Invitation to Bid COMMUNITY CENTER BASEBALL FACILITY

The Confederated Tribes of the Chehalis Reservation Community Center Baseball Batting Facility Project

CHEHALIS TRIBE
BASEBALL BATting CAGES

G000

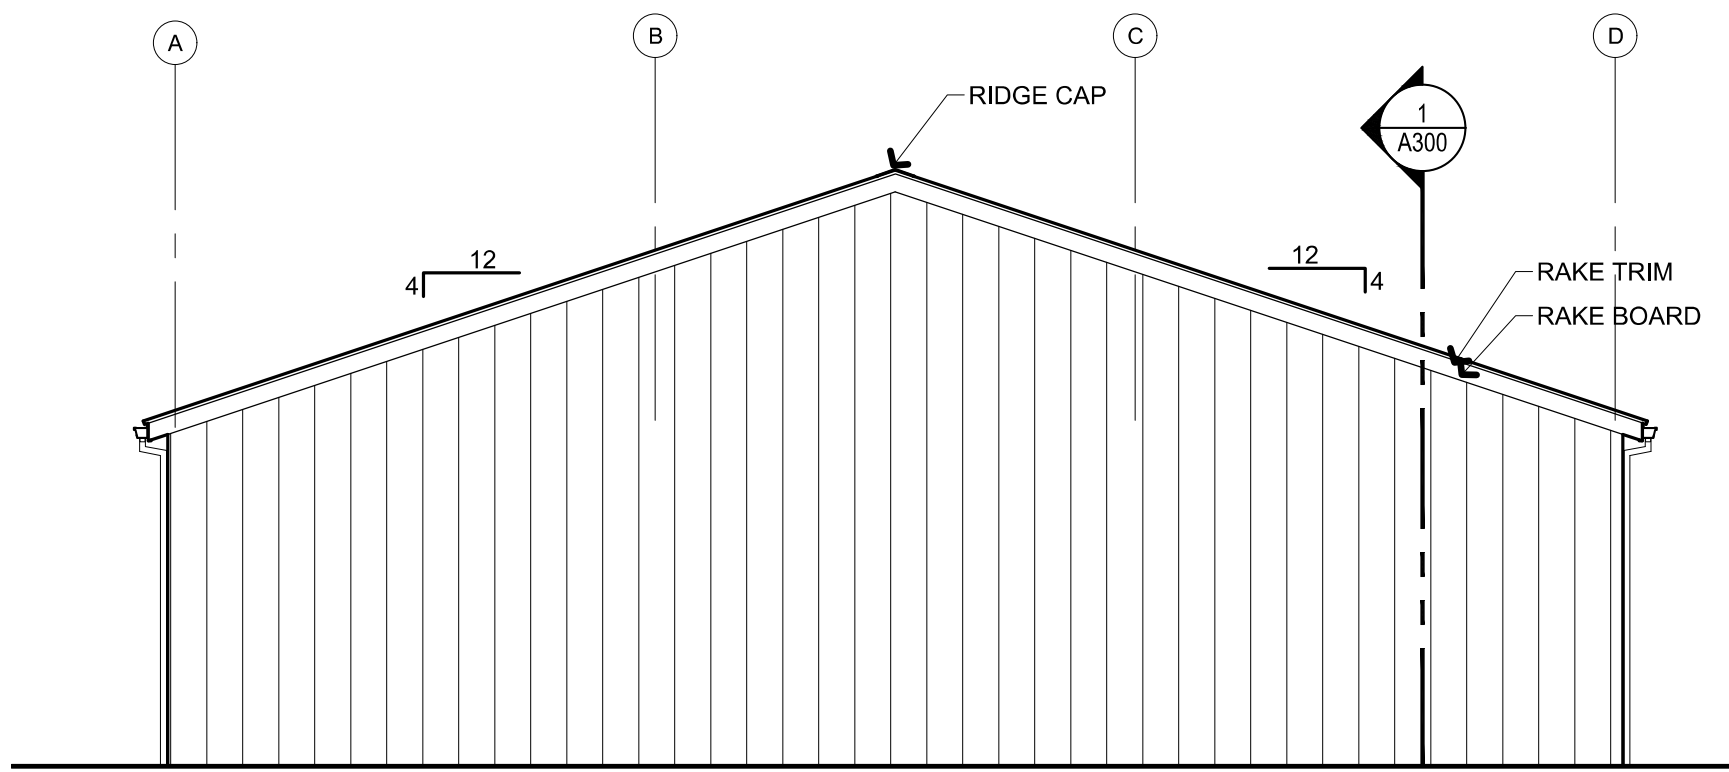
1. Miscellaneous
 - a. This building is not equipped with a fire sprinkler system.
2. Revise A101
 - a. The overall building dimension is 120' long by 60' wide.

- b. Detail 5 – Delete the pads over metal siding.
 - c. Detail 1 – See civil site plan for exterior door locations. All doors shall be insulated metal exterior rated. There are 2 – 8'x8' Exterior Overhead Doors and 2 – 3'-0" x 7'-0" HM Exterior Door and HM Frames.

- d. Detail 1 – Delete chain link fence and gate inside the building.
 - e. Detail 1 – Batting netting are not a sole source item.
 - f. Metal shall be 29 GA Colored Steel. Owner will pick color from contractor provided color chart.

- g. Reflected Ceiling Plan Lighting: The lights shall be Lithonia Lighting CPHB 30LM MVOLT 50K Compact PRO LED Bay Light, High Bay, 30000 Lumens, 5000K Light (20 ea)

PERMIT
SET
SECTIONS AND
DETAILS

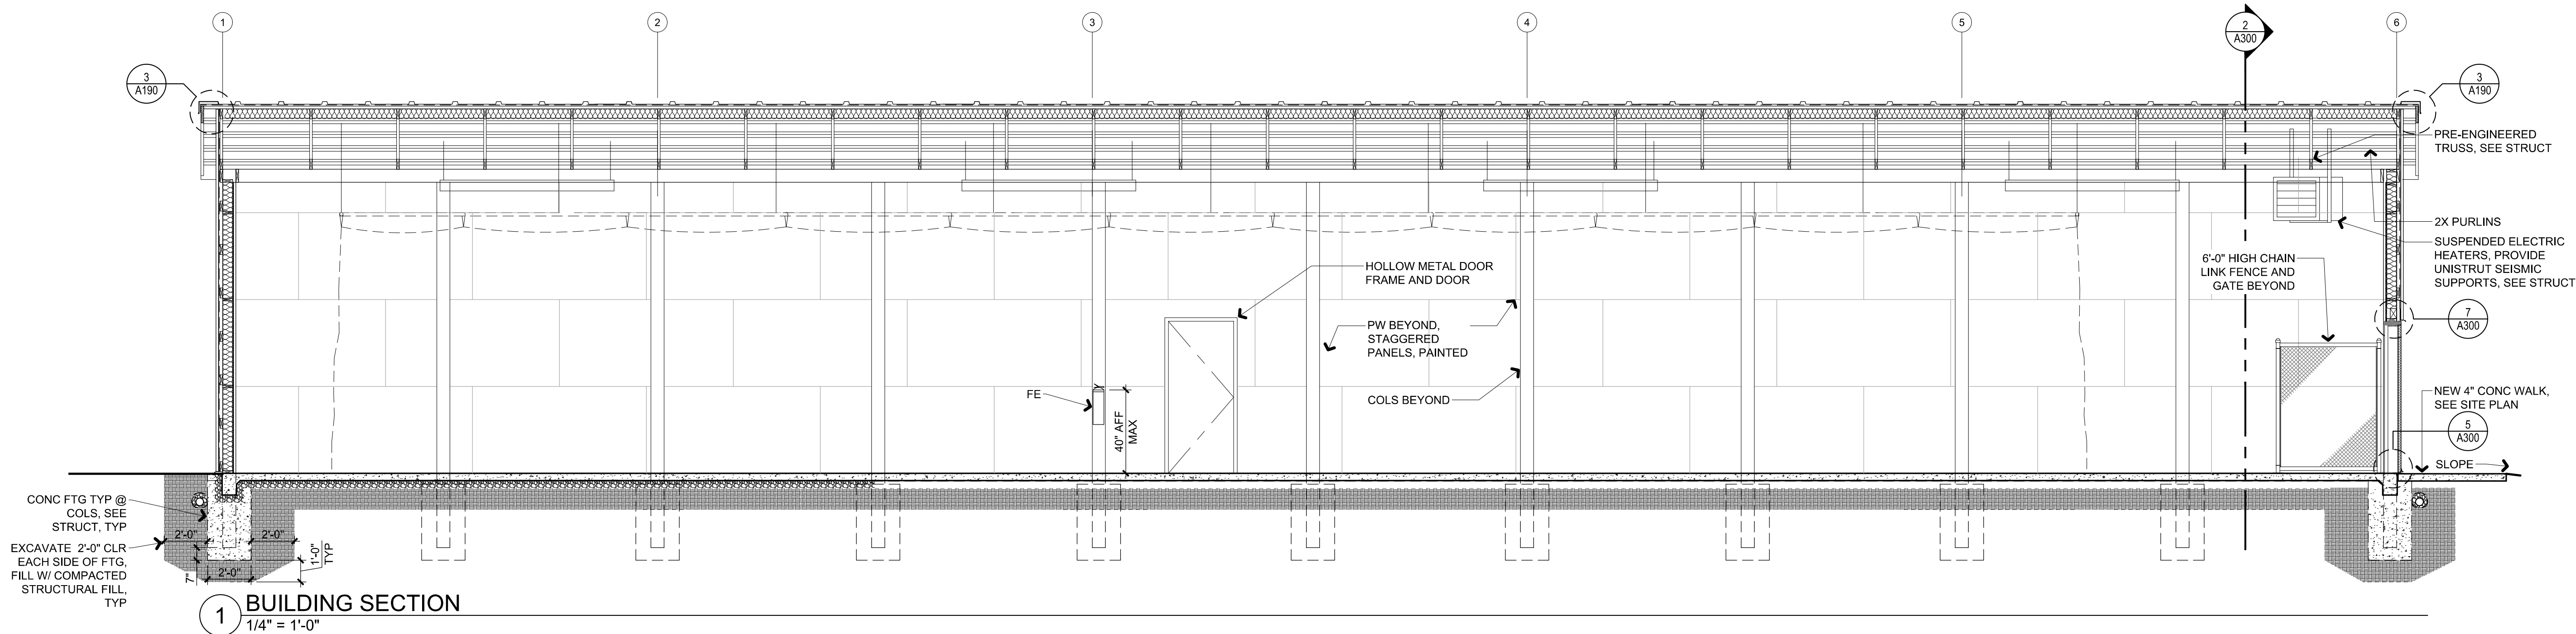
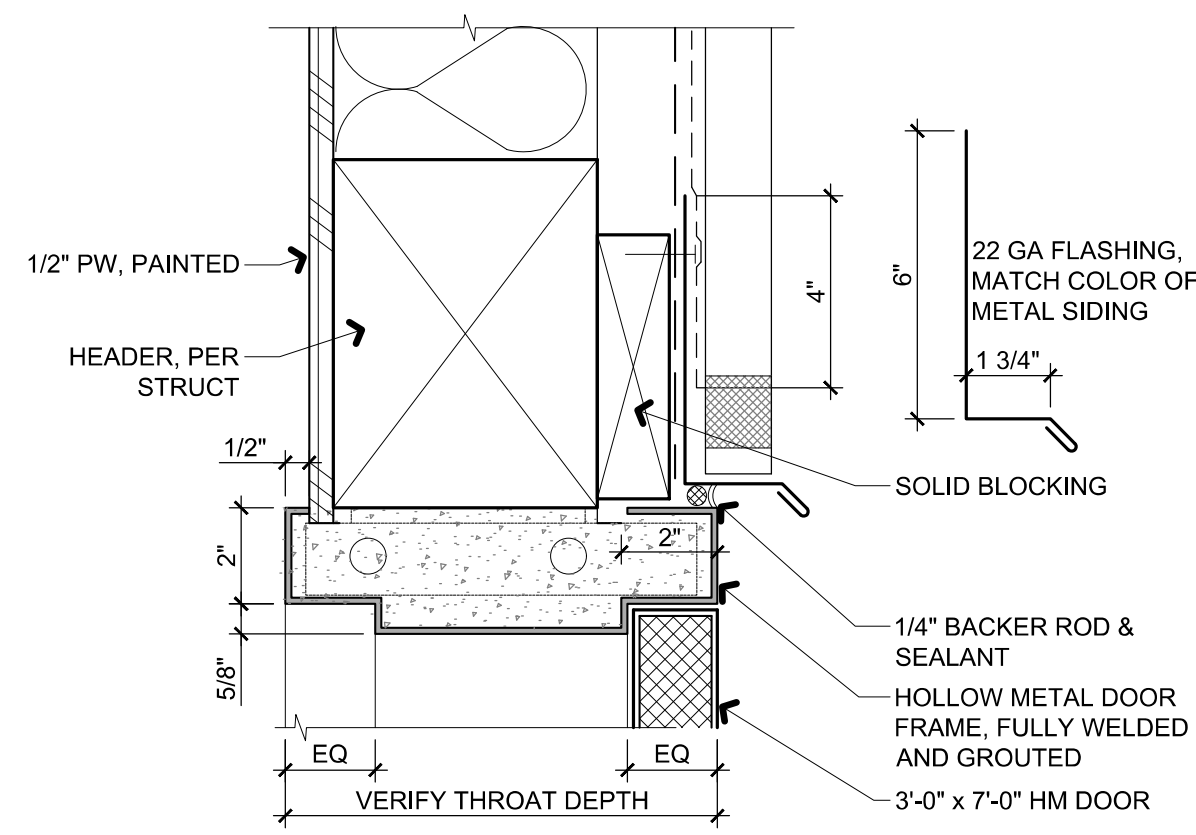
- n.
3. Revise A300
- a. Detail 7 – Header for all doors shall meet prescriptive building codes.
 - b. Detail 1 - Exterior doors per civil site plan
 - c. Detail 1 - Delete chain link fence inside building

INTERIOR SPACES AND RESTROOMS
BASEBALL BATTING CAGES
CHEHALIS TRIBES PLANNING DEPT
402 HOWANUT RD
OAKVILLE, WA 98568
360.709.1813

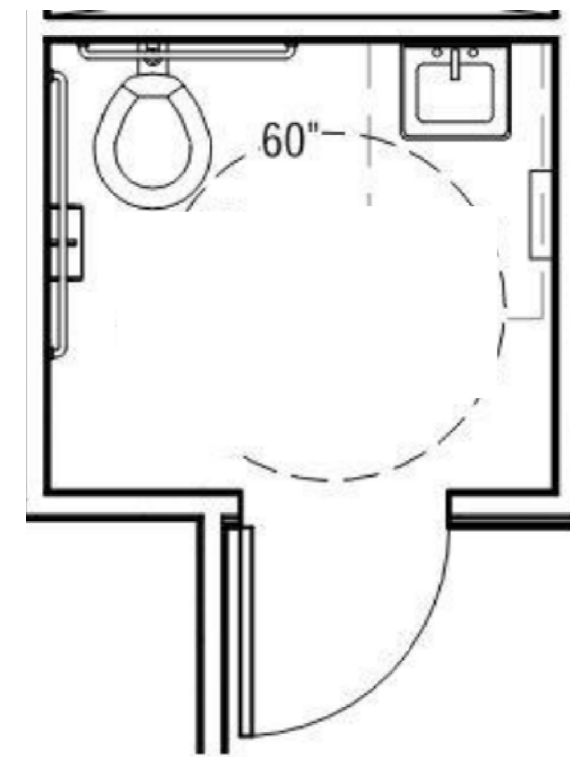
1. Electrical Supply
 - a. Electrical supply is not included in this bid. Owner will coordinate with local PUD for design and installation of electrical from source to building footing. Contractor to provide a LF for trenching.
2. Revise A-1 Interior

4. Revised G000 – Fire Retardant Notes
- a. Fire treatment and flame spread requirements are not required for framing and plywood
5. Revise A-1 Interior – Insulation

6. Revise A-1 Interior – GWB
- a. All walls in office, storage and bathrooms shall be Moisture Resistant GWB. (Both sides of walls where plywood is not called out)
